CURRENT
EMERGENCY PLAN
IMPLEMENTING PROCEDURES
TABLE OF CONTENTS
Volume 3A

PACIFIC GAS AND ELECTRIC COMPANY
DEPARTMENT OF NUCLEAR PLANT OPERATIONS
DIABLO CANYON POWER PLANT UNIT NOS. 1 AND 2

TITLE: NEW/REVISED/RESCINDED OFFICIAL PROCEDURE INSTRUCTION SHEET

Procedure No. EP R-1 Rev. 13 Unit No. 1 ☐ 2 ☐ 1 & 2 ☒
Title PERSONNEL INJURY OR ILLNESS (RADIOLOGICAL RELATED) AND/OR OVEREXPOSURE

PACIFIC GAS AND ELECTRIC COMPANY
DEPARTMENT OF NUCLEAR PLANT OPERATIONS
DIABLO CANYON POWER PLANT UNIT NOS. 1 AND 2
SKIN AND CLOTHING DECONTAMINATION REPORT

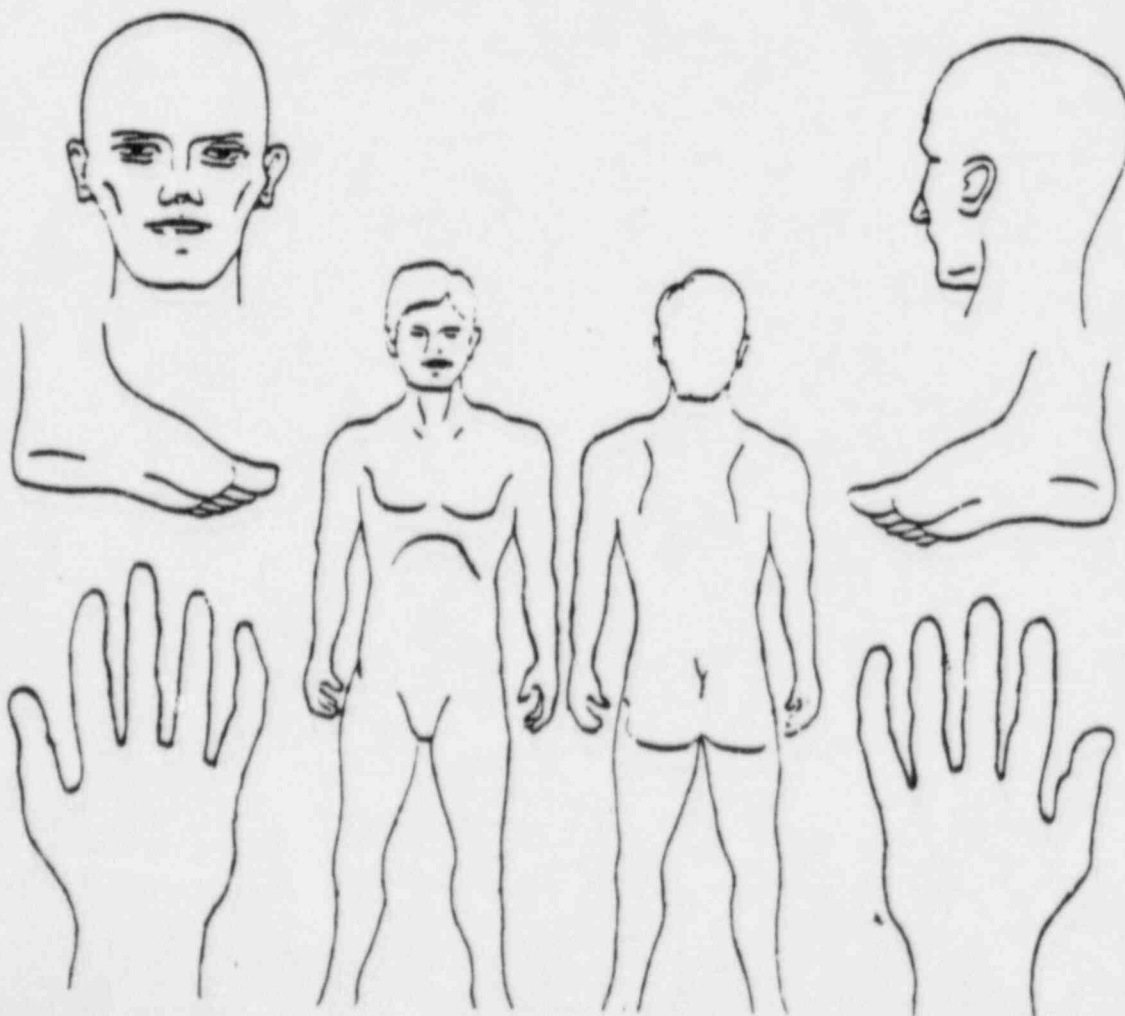
Revised Form dated 4/84, please replace and send back same form dated 7/81 which was sent out w/ EP R-1 Rev 13 on 6-25.
